MEMORANDUM

From:	Catherine Brimble Senior Landscape Officer		
Service	SDL Landscape and Trees	App No:	251981
Address:	Linear Park Phase 3a, Arborfield Garrison & Adjoining Land, Arborfield, Reading.		
Proposal:	Application for the approval of reserved matters pursuant to outline planning permission O/2014/2280 (140977) dated 02/04/2015. The Reserved Matters comprise details of the erection of the Linear Park Phase 3A of the wider site, together with associated landscaping, a substation and an attenuation pond. Details of access, appearance, landscaping, layout and scale to be considered.		
Type of Development:	Minor All other developments		
Site Visit Made:	Yes/No

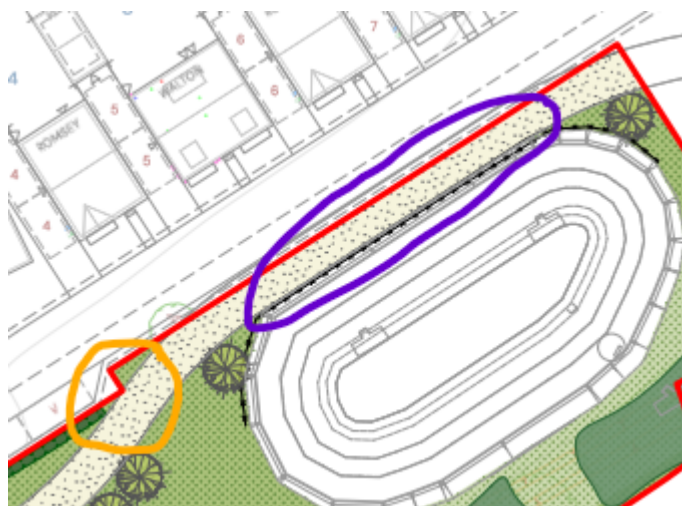
I am concerned that we have this application for part of the linear park adjacent to Parcel N which shows visitor parking bays within the park but related to Parcel N where I previously indicated through pre-app comments for Parcel N that:

The relationship of the development within Parcel N with the Linear Park to the south of the site is crucial and will need to provide a green edge to the development. The Village Green Design Code indicates the roads within the development cells should have the character of 'Leafy Streets' and therefore we will be expecting street trees adjacent to the boundary with the Linear Park. The necessity and inclusion of street trees is also highlighted in the NPPF Paragraph 136. I note the footway adjacent southern boundary has now been removed however very few trees are shown to be planted (2 no.) with extensive visitor parking bays (12 spaces). This is still not an acceptable solution Parcel's N relationship to the open space.

The development edge to the Linear Park around Parcel will need to replicate that on the other side of the park opposite Parcel P. Therefore, the parking bays will need to be removed.

I note that there is an existing basin in the location of the proposed basin (C72) which will be increased in size. Is it possible to slightly amend the shape of the basin in order to pull the north-western edge of the basin away from the proposed footpath? The plan as shown indicates that footpath sandwiched between the edge of the road and the top of the basin with no appropriate landscape edge. The basin therefore is shown to be fenced because of the close proximity of the footpath to the top of the basin. See snip below with the area highted in purple. This will need to be considered further to allow for a better design solution to be provided and improve the pedestrian experience using this route in this location.

It is not clear what the existing and proposed ground levels are in relation to the park, footpath and basin and how these relate to the adjacent highway. These will need to be provided.

Due to the position of the parking bays (which need to be removed) and alignment of the footway to route around the basin in the area shown in orange in the snip above, the end of the proposed hedgerow to the back of the parking bays is not sustainable as it will grow out into the footpath. This area will need to be reconsidered to take account of my comments.
